CITY OF ALBUQUERQUE

**RE: Lot 13 Block 13 Unit 5 SAD 227
8004 Fuji NW
Grading and Drainage Plan
Engineers Stamp Date 10/8/2020 (E10D088)
Pad Certification Date 10/8/2020**

DRAINAGE AND TRANSPORTATION INFORMATION SHEET (REV 6/2018)

ENGINEER'S SEAL	LOT 13 BLK 13 U 5 VC 8004 FUJI CT. NW	DRAWN BY DEM
 10/8/20		DATE 10-8-20
	GRADING AND DRAINAGE PLAN	LOT 13 BLK 13 U 5 VC DWG
	DAVID SOULE P.E. #14522	 <i>Rio Grande Engineering</i> 1606 CENTRAL AVENUE SE SUITE 201 ALBUQUERQUE, NM 87106 (505) 872-0999
JOB # _____

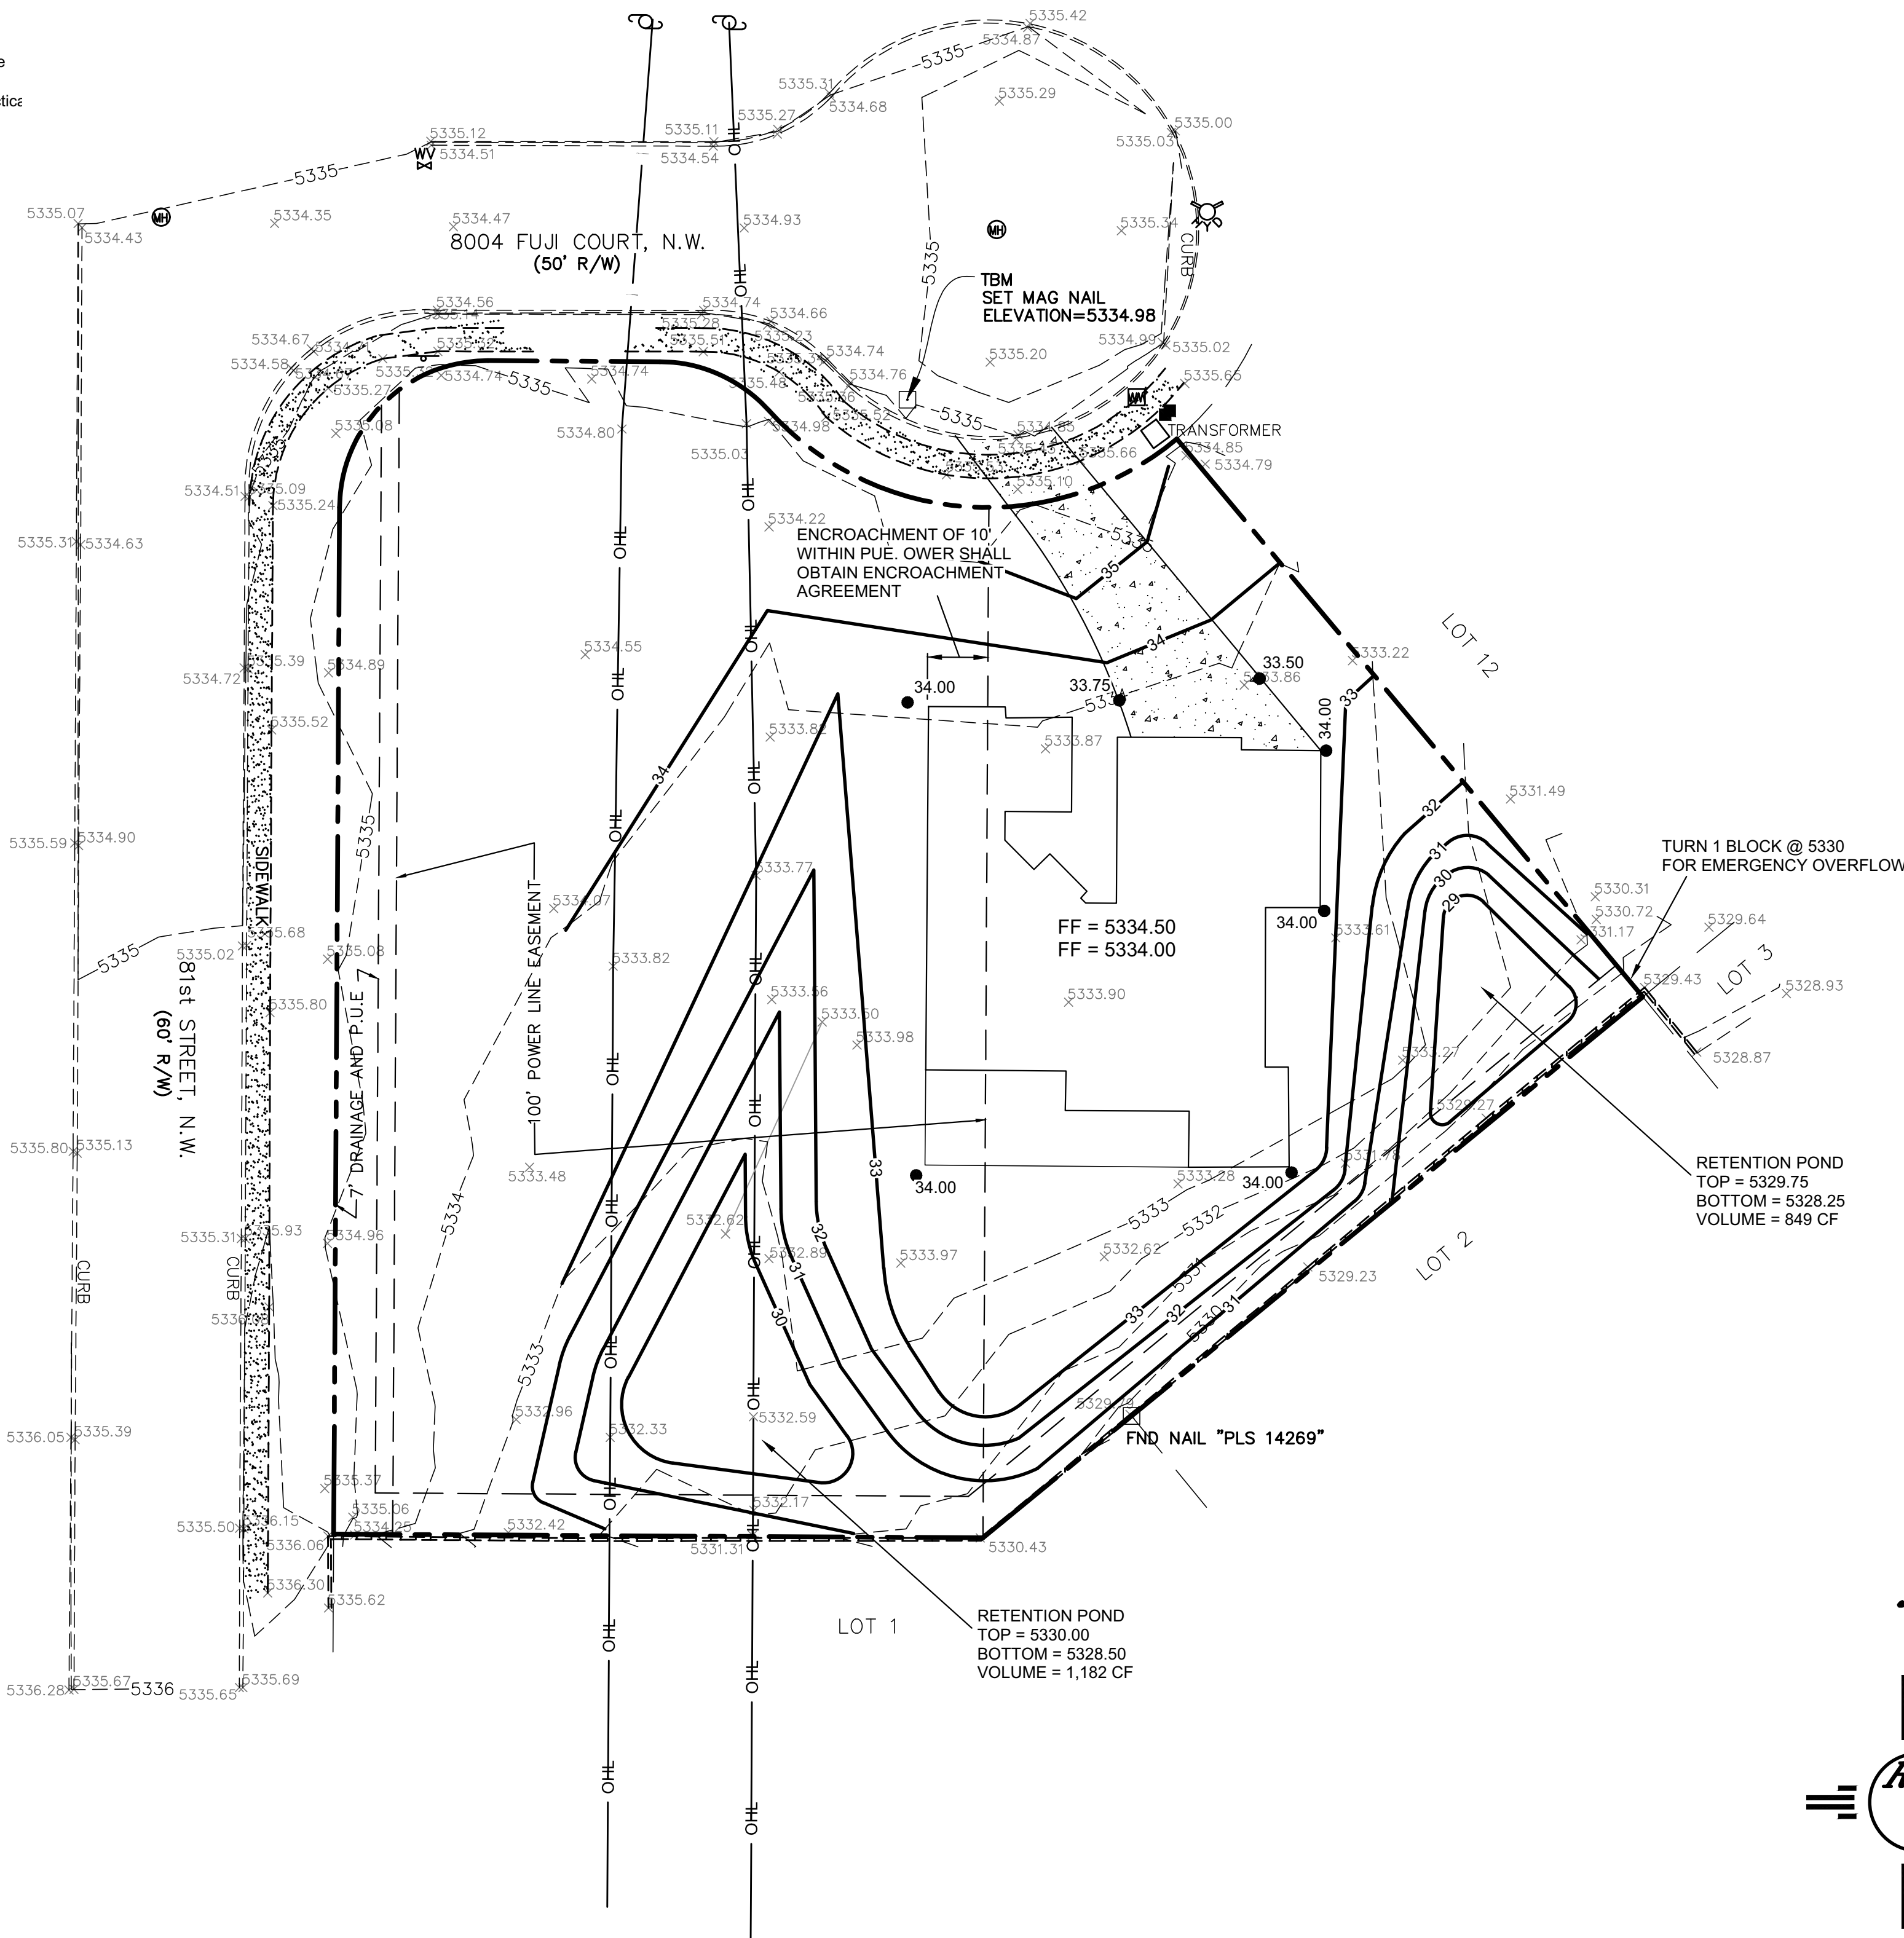
Based upon the information provided in your submittal received 10/9/2020, this plan is approved for Building Permit.

Reiterate to the Owner/Contractor that a separate permit for a garden/retaining wall must be obtained, with the approved G&D plan.

Prior to Certificate of Occupancy release, Engineer Certification per the DPM checklist of this plan will be required.
